## APPLICATION FOR A SPECIAL USE PERMIT

APPLICATION #: **SUP26-0015**  
APPLICANT: Toledo Masjid of Al-Islam  
OWNER: Toledo Masjid of Al-Islam  
ADDRESS: 722 E. Bancroft Street  
PARCEL(S): 02-01544  
ZONING: RD6 (Duplex Residential)  
NEIGHBORHOOD: Sherman  
REPORT DATE: May 1, 2026  
HEARING DATE: May 14, 2026  
STAFF REVIEWER: Schultz

The applicant is requesting a Special Use Permit for a new cemetery at 722 E. Bancroft Street. Cemeteries require a special use permit in residentially zoned districts.

Proposed site plan for the new cemetery.

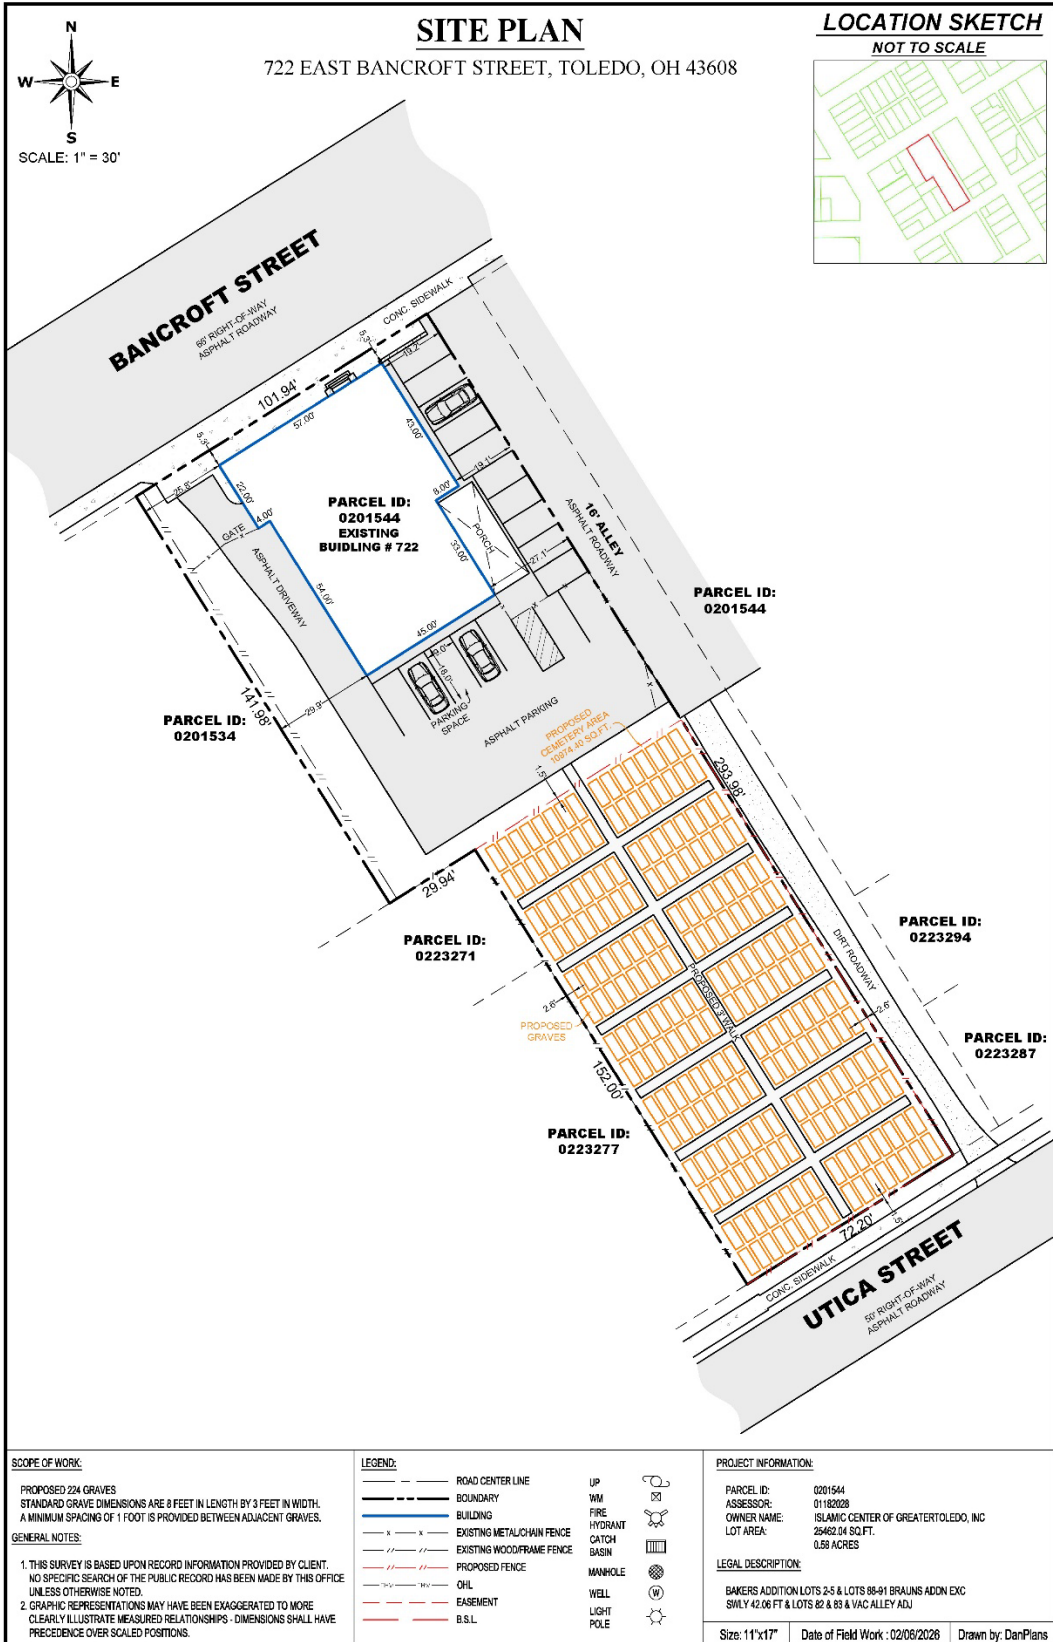
- (a) *1108.0202 Frontage Greenbelt.* A fifteen-foot (15') wide frontage greenbelt consisting of one (1) tree for every thirty feet (30') of frontage is required along Utica Street. – Not acceptable as depicted. The applicant shall submit a revised site plan.

- (a) *1107.1700 Accessible Parking for Physically Disabled Persons.* A van accessible parking space must be provided. Such space must be adjacent to an 8' wide loading aisle and be located in close proximity to building entrances. Accessible parking signage must be installed compliant with TMC§1107.1704. – Not acceptable as depicted. The applicant shall submit a revised site plan.
- (b) *1107.1911 Dimensions.* All altered parking areas must comply with the dimensional standards of this section. – Not acceptable as depicted. The applicant shall submit a revised site plan.

- 1. The applicant shall submit a revised site plan to the Plan Director and Division of Traffic Management for review and approval depicting the following:
  - a. All driveways, parking spots, and drive aisles must be clearly shown and dimensioned in accordance with TMC§1107.1911. This includes clearly showing the 16' alley approach.
  - b. All parking spaces are required to be a minimum of 9'x18' per TMC§1107.1911.
  - c. Parking spaces shown on the plan which are not a minimum of 9'x18' shall be removed.
  - d. A van accessible parking space with an 8' wide loading aisle must be clearly shown with accessible parking signage per TMC§§ 1107.1702, 1107.1702, & 1107.1704.

- e. Accessible parking signage must be posted directly in front of the parking space at a height of no less than 60 inches and no more than 72 inches above pavement level per TMC§1107.1704.
- f. Wheel stops are required at all parking spots that abut sidewalks, property lines, planting strips, and buildings per TMC§1107.1907.
- g. Traffic flow must be clearly indicated on drawings utilizing ground painted arrows where one-way traffic flow is being utilized.

9. The applicant shall submit a revised plan to the plan director depicting a fifteen-foot (15') Frontage Greenbelt along Utica Street which includes a minimum of two (2) trees.
10. The Special Use Permit may be reviewed for compliance with the conditions of approval, negative secondary effects, and adherence to all requirements of the Toledo Municipal Code. If outstanding issues are found and not addressed the Special Use Permit may be considered for revocation.
11. Minor adjustments to the site plan that do not violate the above conditions, or the Toledo Municipal Code, may be reviewed and approved by the Director of the Toledo City Plan Commission.
12. No permits shall be issued until arrangements satisfactory to the Director of the City of Toledo Plan Commission have been made for compliance with the conditions as set forth above.
